Dayton Parkway Master Plan

DRAFT February 2024
for review only

PLANNING COMMISSION AGENDA

**APPROVAL OF THE PRELIMINARY PLAT AND FINAL PLAT OF KWICK TRIP 1187,
CONDITIONAL USE PERMIT FOR A MOTOR FUEL STATION, AND SITE PLAN REVIEW**

SITE PLAN		
CONVENIENCE STORE #1187		
W/ SIDE DIESEL		
MAPLE COURT DAYTON, MN		
#	DATE	DESCRIPTION
△	2021 10/22	ADDED SIGN 16 & 17
DRAWN BY		KMK
SCALE		MULTIPLE
PROJ. NO.		0001
DATE		2021-08-18
SHEET		SP1

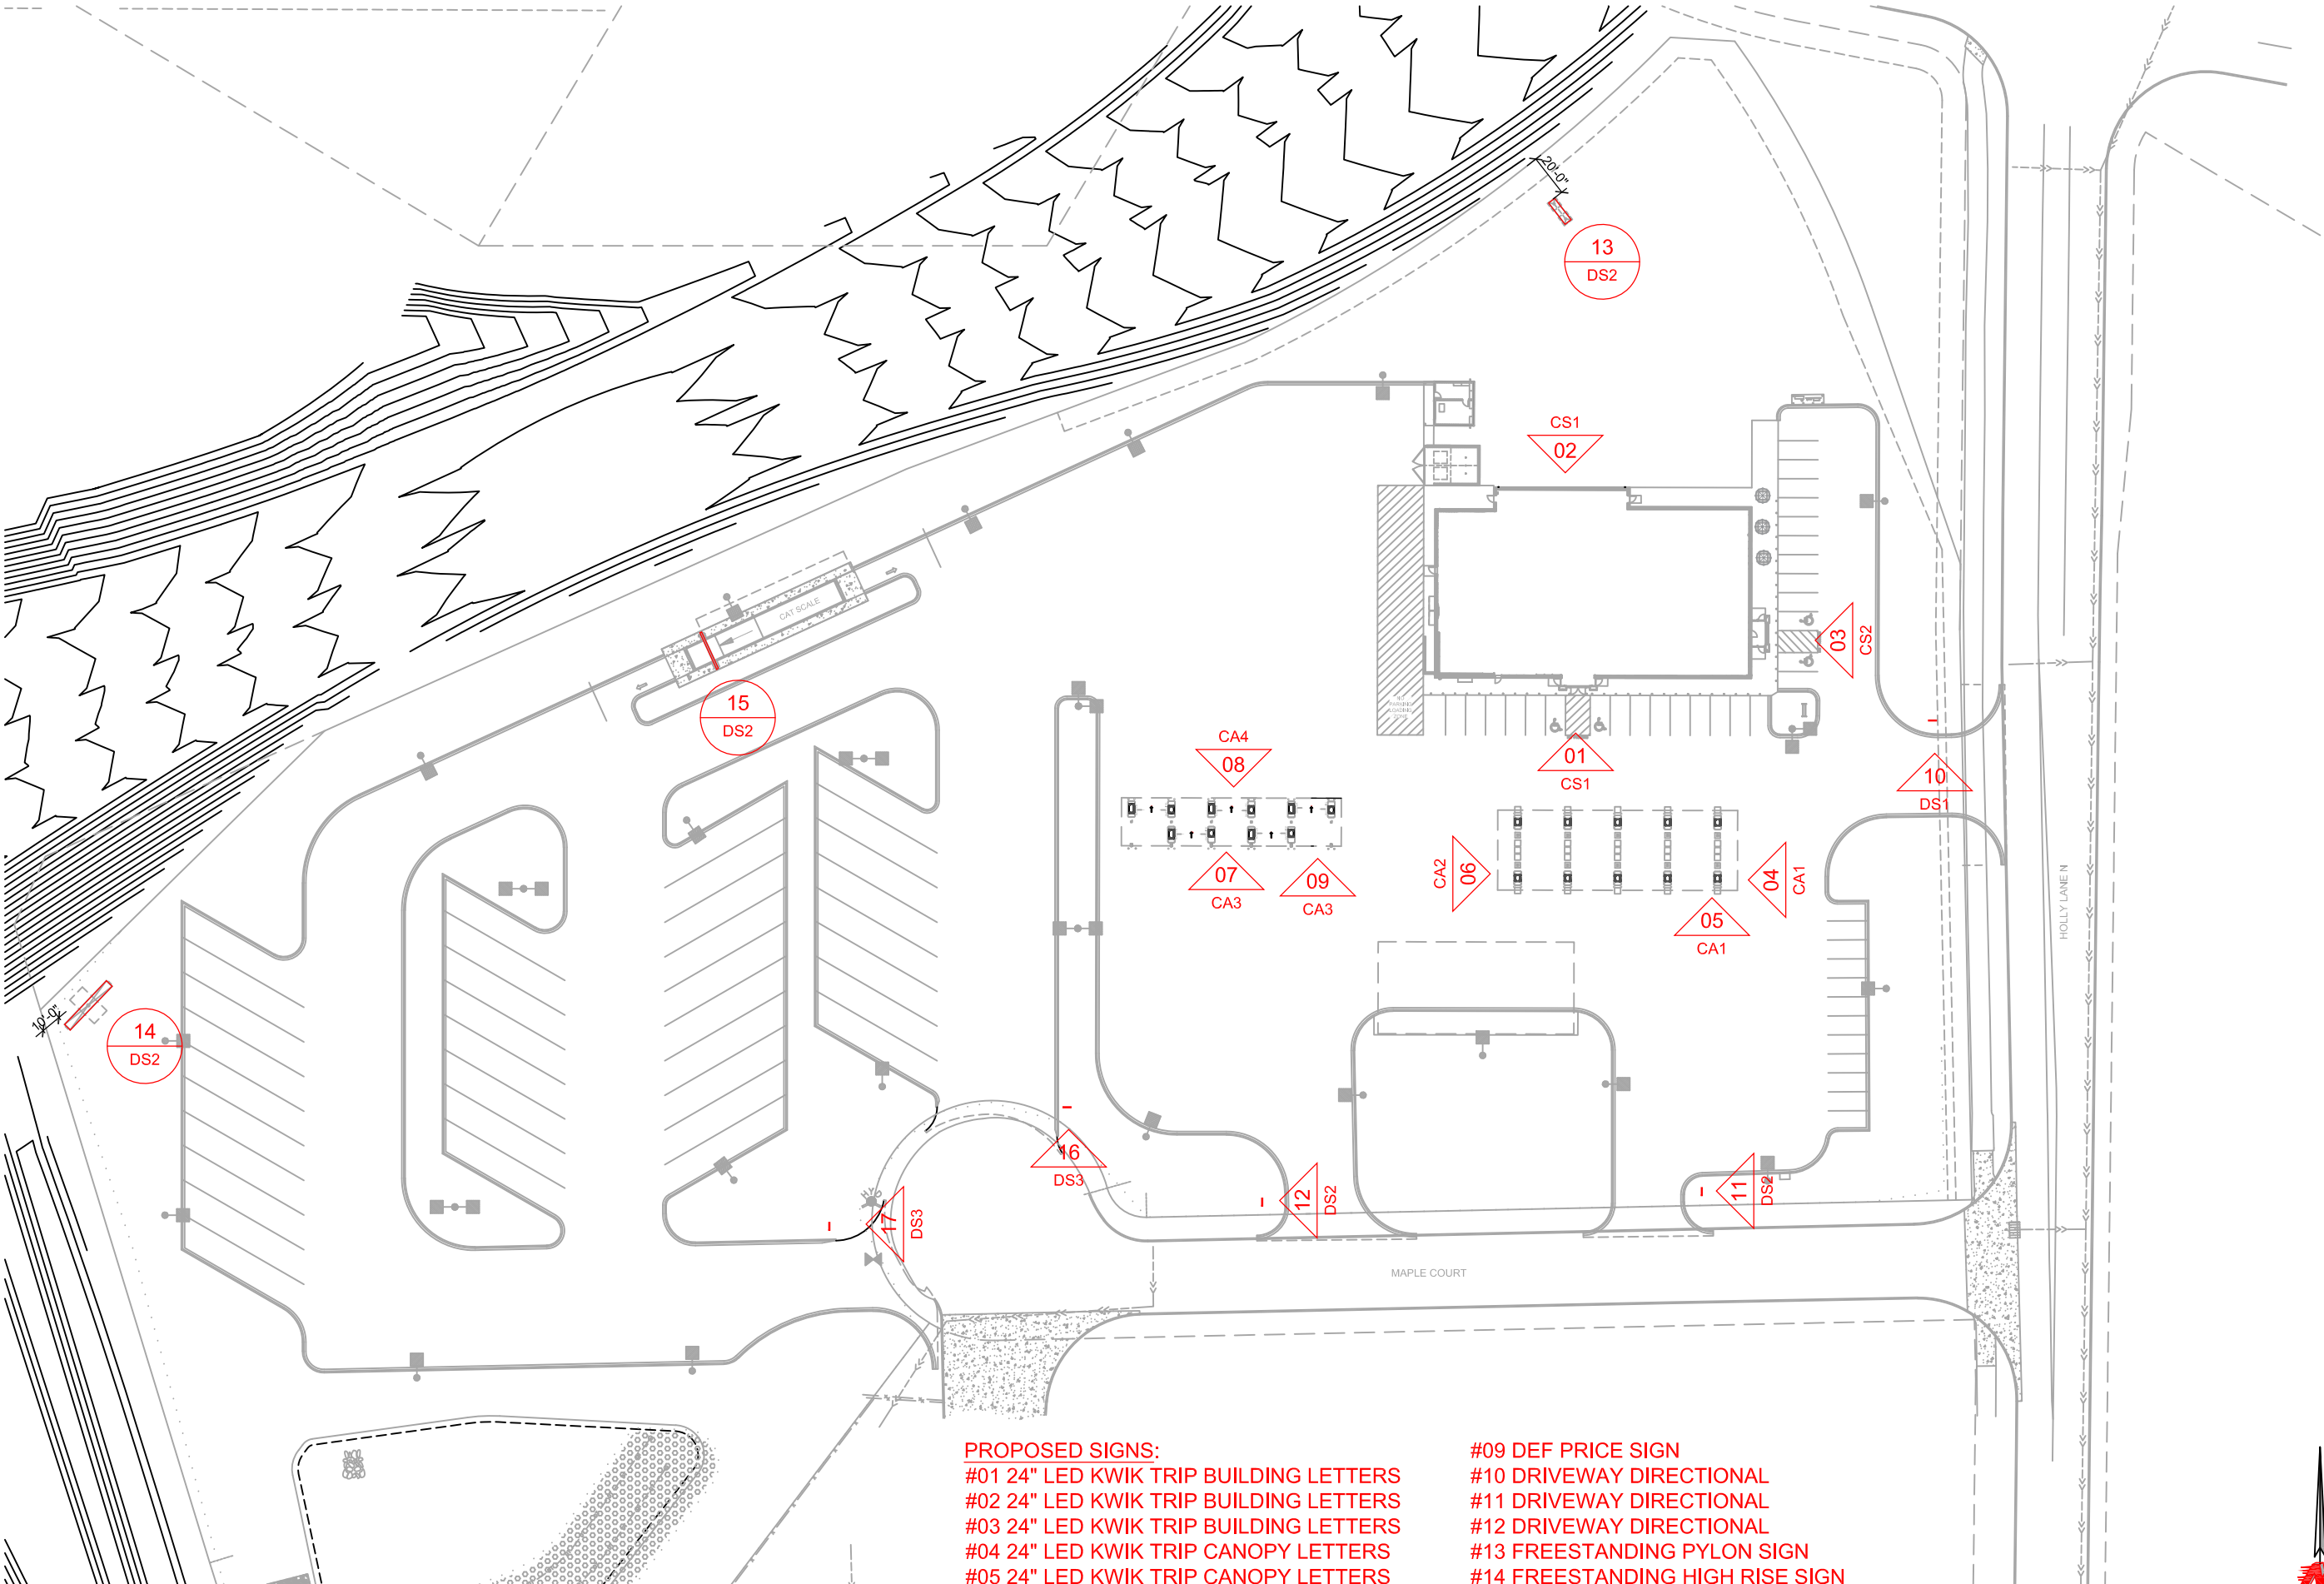
Staff suggests that the Applicant provide an alternative Landscape Plan for City Council review, with the required number of shrubs shown. The Council may opt to reduce the number required based on site conditions.

Landscaping. 1,200 additional shrubs are required. The Planning Commission should provide an opinion if this is necessary.
